INTERIM OPERATIONAL SUPPLEMENT

USAF SERIES T-38C AIRCRAFT

Title: Exterior Inspection Caution

TO 1T-38C-1S-03

Figure 2-2. Exterior Inspection

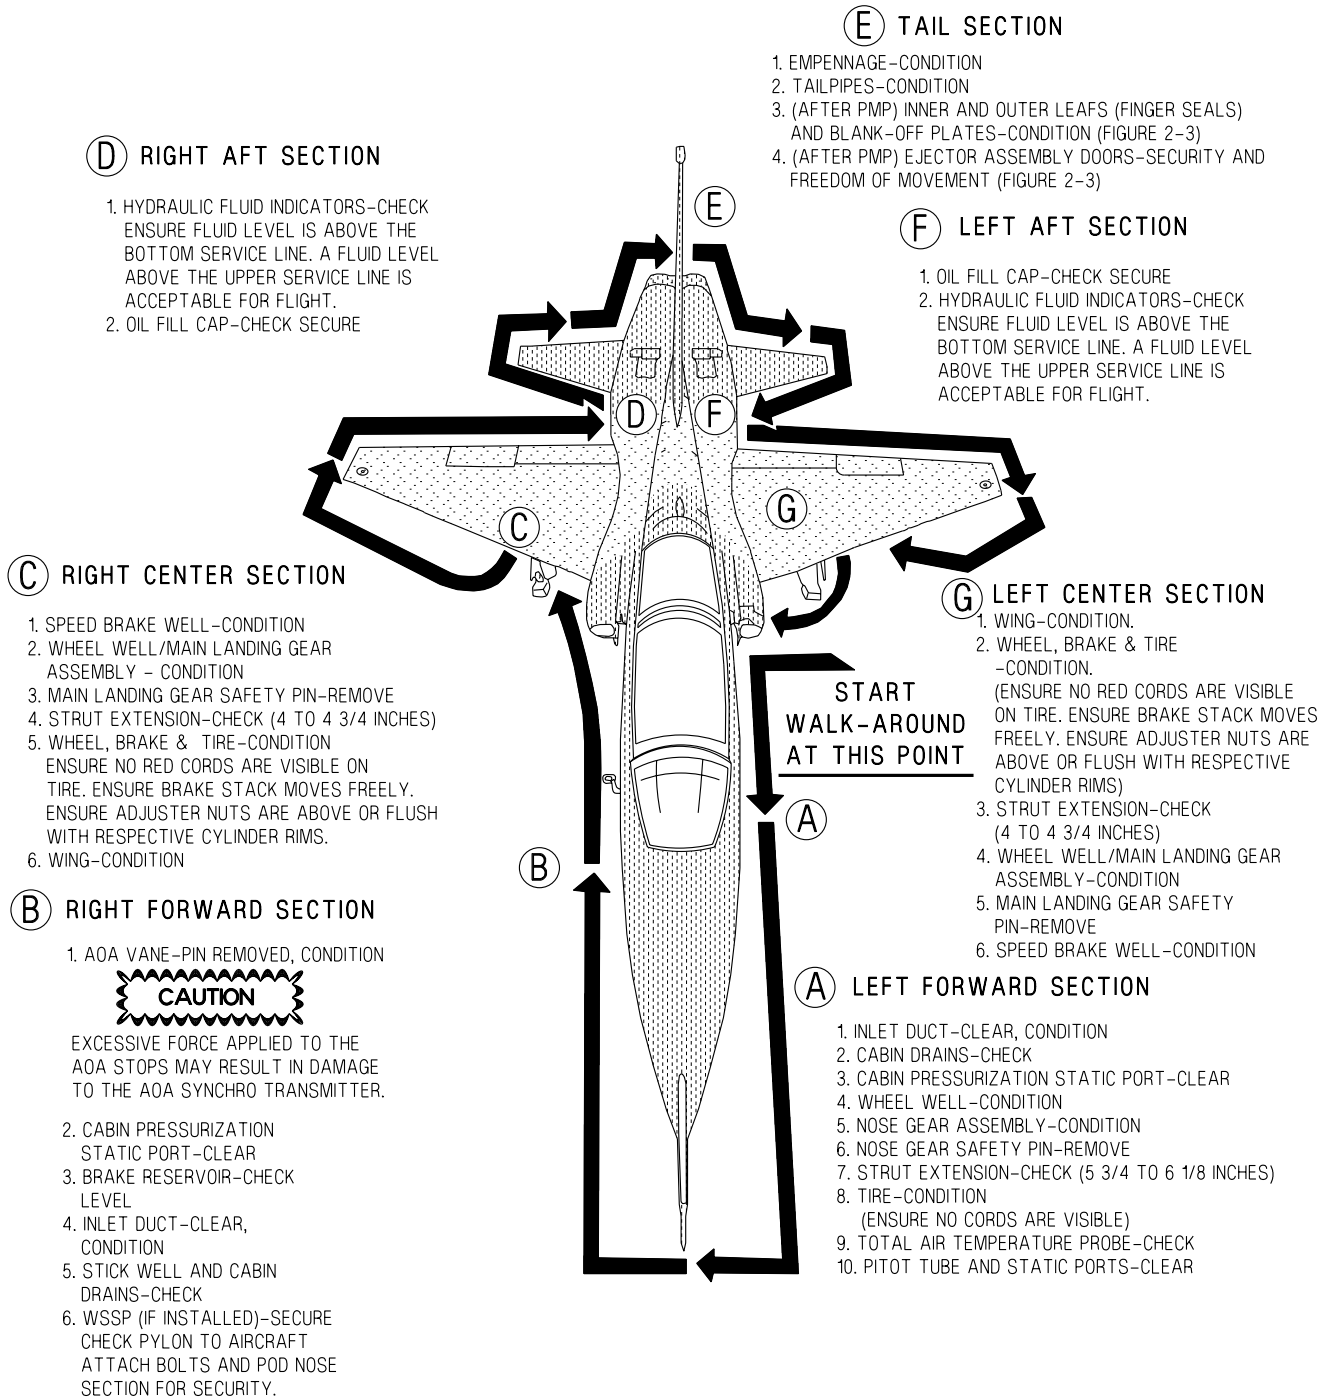
A. In 1T-38C-1, on page 2-5, EXTERIOR INSPECTION, add a CAUTION to read:

“CAUTION
Excessive force applied to the aileron surface may damage the aileron operating mechanism.”
